HISTORIC LANDMARK COMMISSION STAFF REPORT

534 N Wall Street Window Replacement Minor Alteration

PLNHLC2015-00168
Meeting Date: May 14, 2015

DATE:	12/9/2014
SCALE:	
SHEET:	A-2

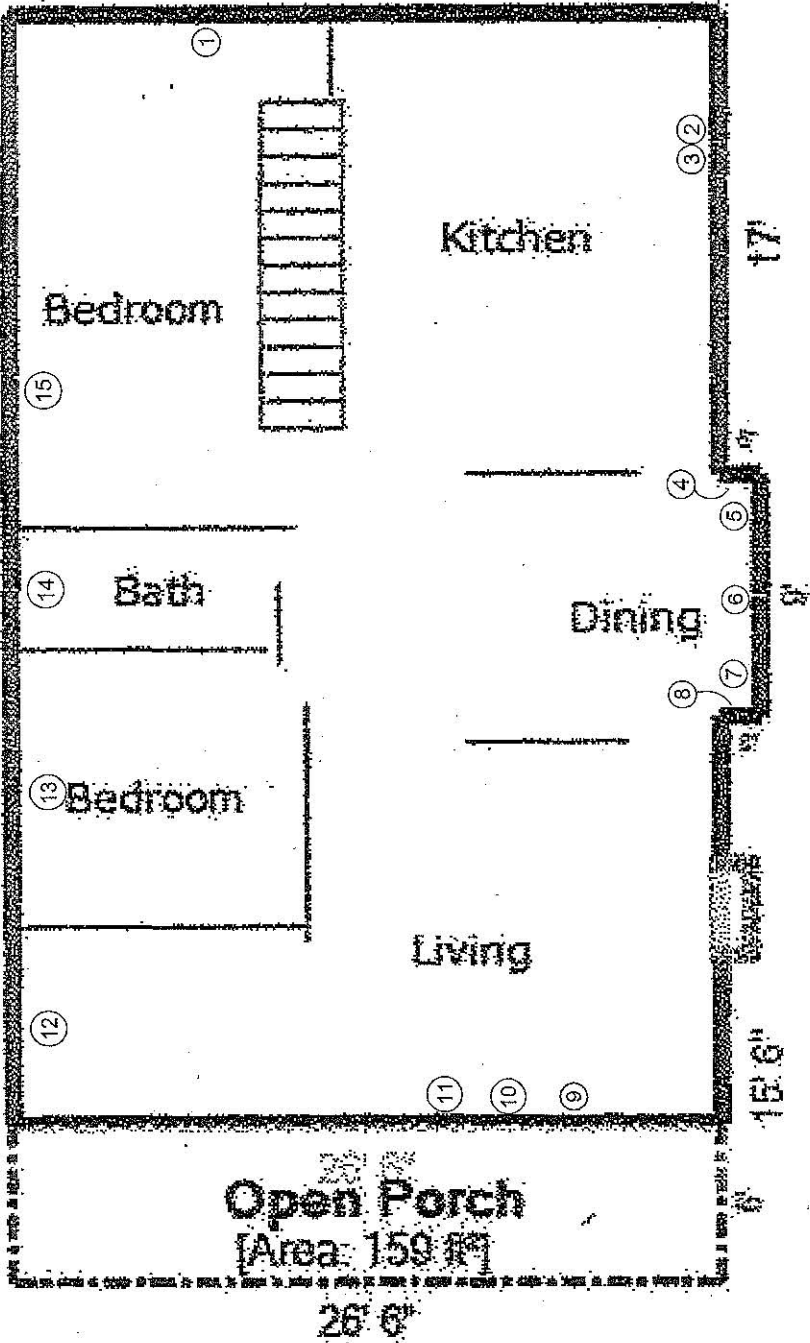
The applicant is requesting a Certificate of Appropriateness to replace the existing street-facing historic windows (labeled 9, 10, 11 on the site plan in Attachment B) with those of contemporary manufacture. These windows were examined by a member of the planning staff in conjunction with a recently issued Certificate of Appropriateness for storm windows and were determined to be in good condition, needing only standard maintenance for continued good function. Photos of the existing windows are provided in Attachment C.

Analysis: The front windows of any home are a character defining feature; this is all the more so the case on an historic structure. Removal and modification of this important architectural feature can alter the historic character of a building and adversely impact its historic integrity. This is especially true at the front of a building because they are readily visible from the public way. The size, shape, proportions, and profile of an original window are among its essential features, and these features vary from those found in a contemporary replacement window in fundamental ways.

Finding: This standard does apply. The replacement of these windows would remove features and finishes that characterize the property and place it in an era of architectural technology and design. The proposal does not meet this standard.

Finding: The existing window can be modified and maintained to both meet the needs of the applicant and retain the historic fabric. The proposed replacement of the front-facing windows does not meet this standard.
